GENERAL MOTORS
DCS7424
URGENT - DISTRIBUTE IMMEDIATELY

Subject: N252537030 - Customer Satisfaction Program
Incorrect Trailer Hitch Label

Models: 2024-2026 Chevrolet Silverado 2500HD/3500HD
2024-2026 GMC Sierra 2500HD/3500HD

N252537030 Incorrect Trailer Hitch Label

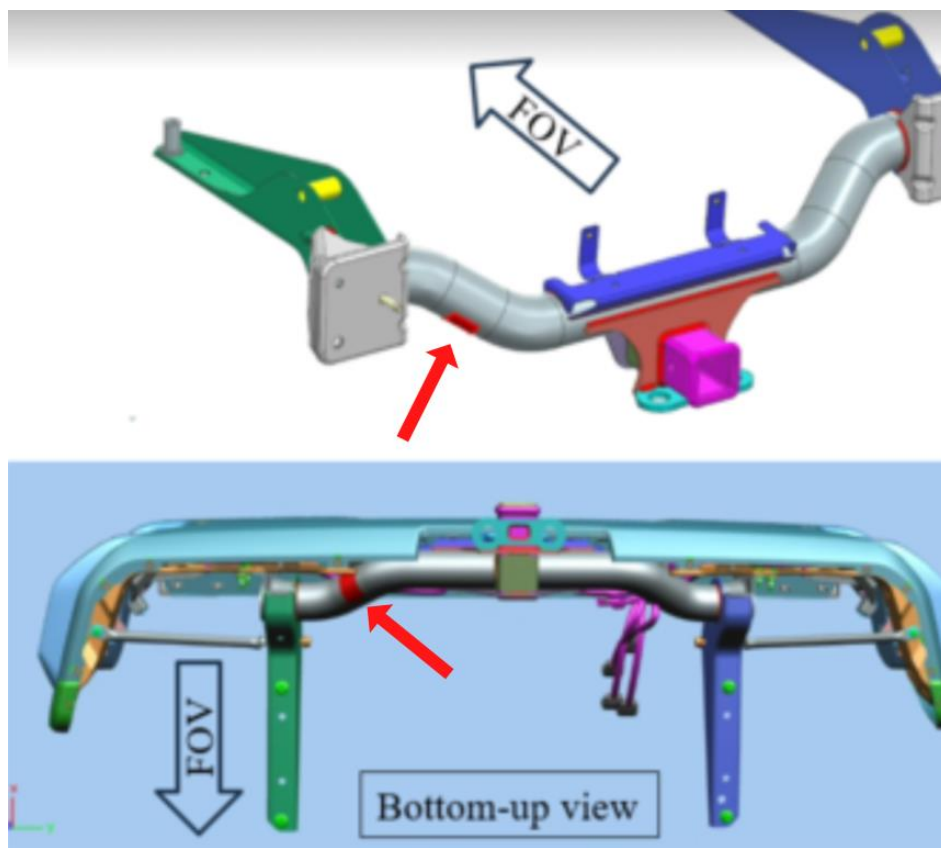
Condition	Certain vehicles listed above, may have a condition where the trailer hitch label understates hitch capability.
Correction	Dealers will remove the sticker on trailer hitch.

Locate and Remove the Towing Capacity Label located on the hitch in the location shown.

Important: This is not a label replacement field action. You are only to remove the label.
